Subject: ESTABLISHMENT OF SERVICE FELT UNDER FLOOR MAT	Bulletin No: 09-012/09
	Last Issued: 03/11/2009

2006-2009 MX-5

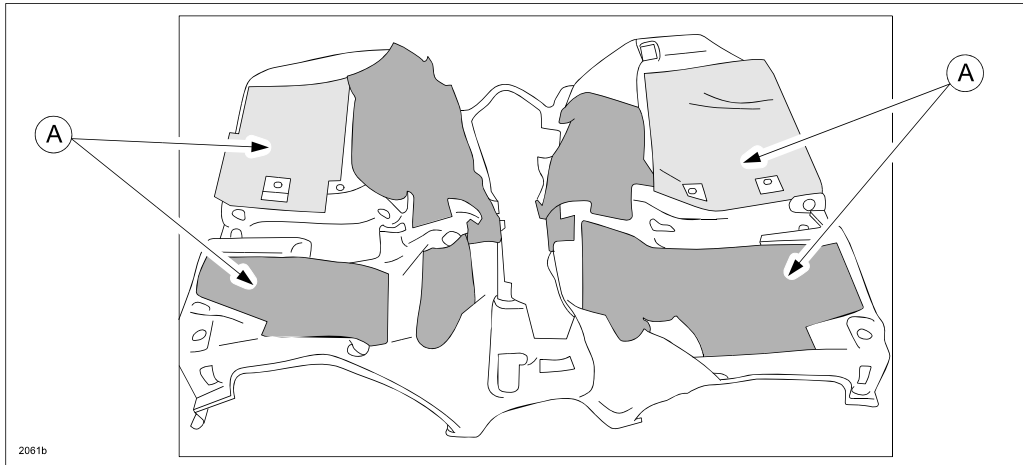
The felt under the floor covering (carpet) has been established as a service part. If the carpet becomes wet due to water entry into the vehicle, normal procedure is to dry and reuse the carpet and felt. However, if the felt has an odor due to water contamination, remove and discard the felt and attach the service felt in the original locations. DO NOT replace the carpet.

This service bulletin has been established to inform of the availability of the felt and the correct procedure for replacement.

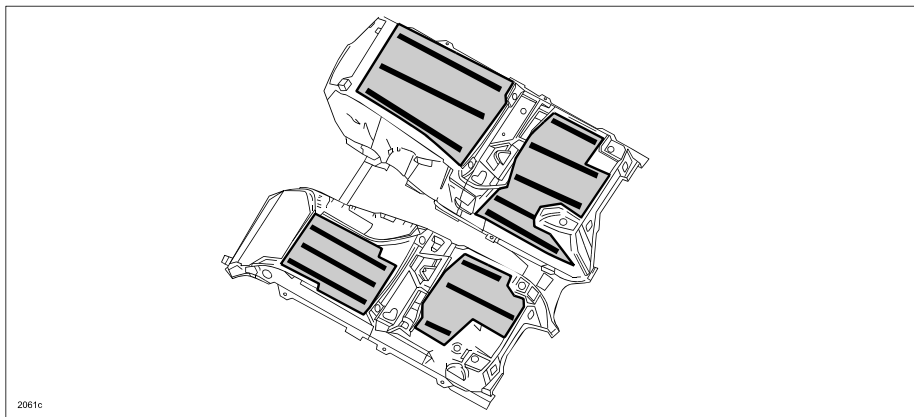
2. Mark location of original felt (A) and remove.

3. Clean bottom of carpet to ensure new felt adhesive attaches properly.

4. Peel backing sheet off service felt and attach to bottom of carpet using marks from original felt placement.
